## **RICHMOND SUBDIVISION, RESUB OF LOT 15**

APPLICATION NUMBER 16 DATE July 11, 2013  
APPLICANT Richmond Subdivision, Resubdivision of Lot 15  
REQUEST Subdivision

# DETAIL SITE PLAN

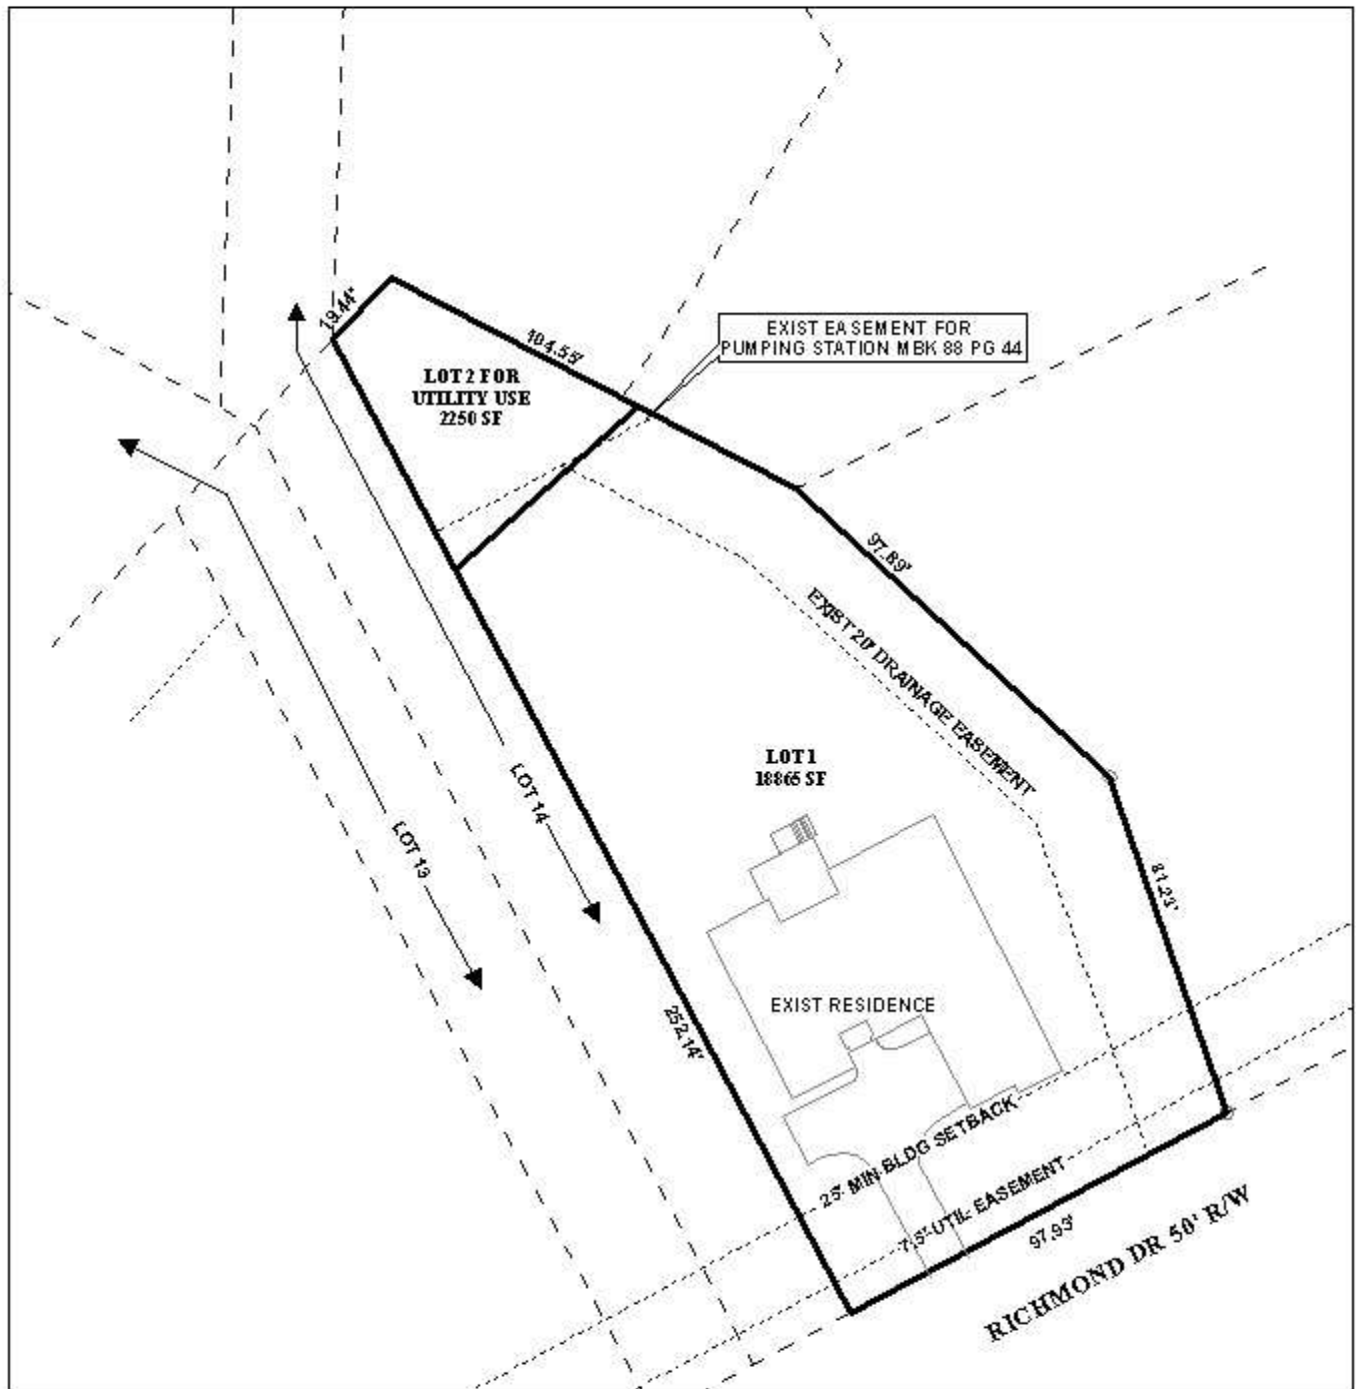
According to the preliminary plat, there is an existing 50-foot easement which runs north-south on the west side of both lots and is meant for “water line, sanitary sewer and ingress & egress to Lots 13 and 14, detention area and sanitary sewer pumping station only.” Lot 2 contains the aforementioned sewer pumping station; therefore, guaranteed access via a paved and gravel utility road within the easement.

The majority of Lot 2 contains existing easements: a 25-foot drainage easement, a 20-foot drainage easement, and an easement for a pumping station. Lot 1 contains existing easements as well: a 20-foot drainage easement which spans the entire east side of the lot, a 7.5-foot utility easement which runs the entire frontage along Richmond Drive, and a portion of the sewer pumping station’s easement which is located on the extreme northern portion of the lot. A note should appear on the Final Plat stating that no permanent structures be constructed within any easement.

It is recommended that the lot size and street frontage requirements for Lot 2 be waived because the proposed lot is landlocked with no road frontage and is not compliant with the minimum lot size requirements.

The 25-foot minimum building setback line and the lot size in square feet are illustrated on the preliminary plat and should be retained on the Final Plat.

Lot 1 fronts Richmond Drive with a compliant 50-foot right-of-way and as a result, no dedication is needed. The proposed lot has one existing curb-cut along Richmond Drive and as a means of

access management, a note should be placed on the Final Plat limiting Lot 1 to the existing curb-cut.

- 1) the lot sizes and the 25-foot minimum building setback line should be retained on the final plat;
- 2) the lot size and street frontage requirements for Lot 2 be waived;

- 3) placement of a note on the Final Plat stating for utility use only;
- 4) illustrations of all easements should be retained on the Final Plat along with a note stating that no permanent structures be constructed in any easement;

- 5) placement of a note limiting Lot 1 to existing curb-cut;
- 6) placement of a note on the Final Plat stating: “Must comply with the Mobile County Flood Damage Prevention Ordinance. Development shall be designed to comply with the storm water detention and drainage facility requirements of the City of Mobile storm water and flood control ordinances, and requiring submission of certification from a licensed engineer certifying that the design complies with the storm water detention and drainage facility requirements of the City of Mobile storm water and flood control ordinances prior to the issuance of any permits;” and

- 7) retention of notes on the final plat relating to endangered/threatened species, buffering of commercial development, and storm water compliance.
